300 AREA SOLVENT EVAPORATOR CLOSURE PLAN, REVISION 3

DOE/RL-88-08
Revision 3B

300 Area Solvent Evaporator Closure Plan

**NOTICE OF DEFICIENCY-RESPONSE TABLE
FOR THE
300 AREA SOLVENT EVAPORATOR**

1 Figure 1-1. Hanford Site and Regional Map:

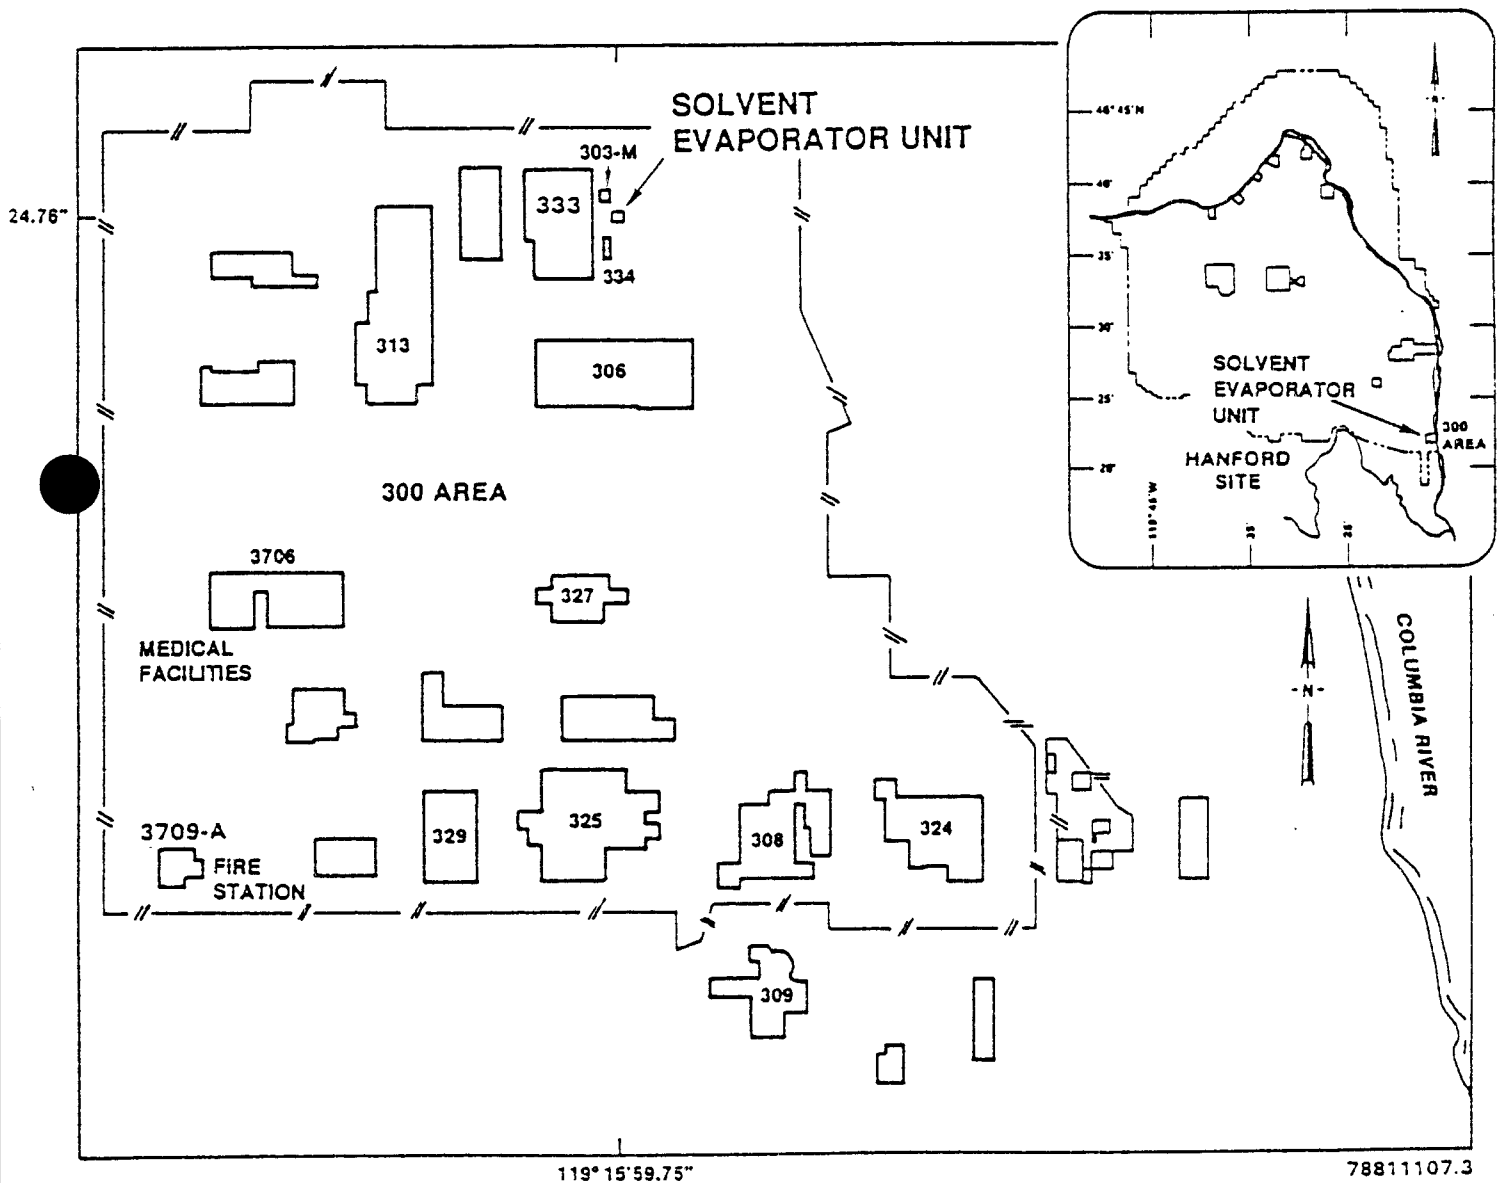
2.	<u>Page 1-1.</u> Typo. "51 FED. Reg. 7722" should be correctly cited as "51 FR 7722". Response: Agree. Typo will be corrected.	<u>1-1, 12</u>
3.	<u>Page 1-3.</u> The 3000 Area is not labeled on Figure 1-1. Please indicate the location of this area on the map. Response: Agree. Typo will be corrected.	<u>1-4, Fig. 1-1</u>

1 Figure 1-3. Layout of the 300 Area Solvent Evaporator Closure Areas
2 and 618-1 Burial Ground.

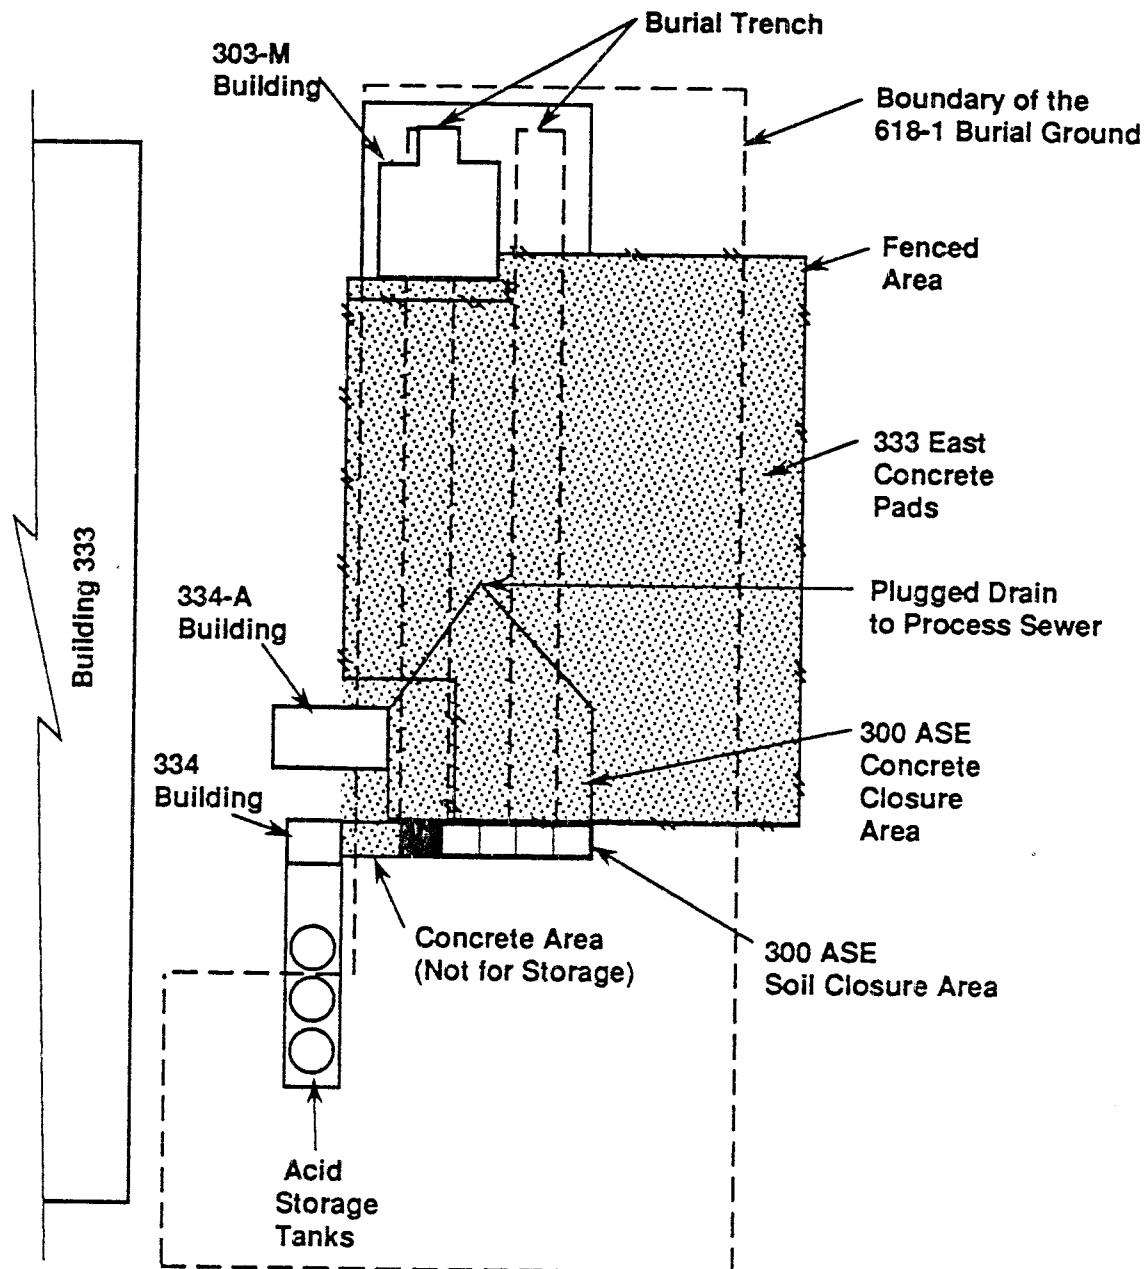
4.	<u>Page 1-10.</u> The concrete pad which "was used as a storage pad that included storage of solvent barrels" must be considered as part of the 300 ASE or as a separate RCRA storage facility. The 90-day storage exemption does not apply because, as indicated on 1-22, "drums were typically stored from six months to one year before the waste was poured into the evaporator". The extent of the pad which was used for storage must be delineated and addressed in this closure plan and in any applicable 300-FF-2 Operable Unit documentation. (WAC 173-303-200(1)(a)) Response: Agree. An extensive search of historic records produced a better definition of the locations of the 300 ASE and associated solvent drum storage. The Closure Plan will be revised to include all identified historical 300 ASE locations and drum storage areas.	<u>1-6, Fig. 1-3</u>
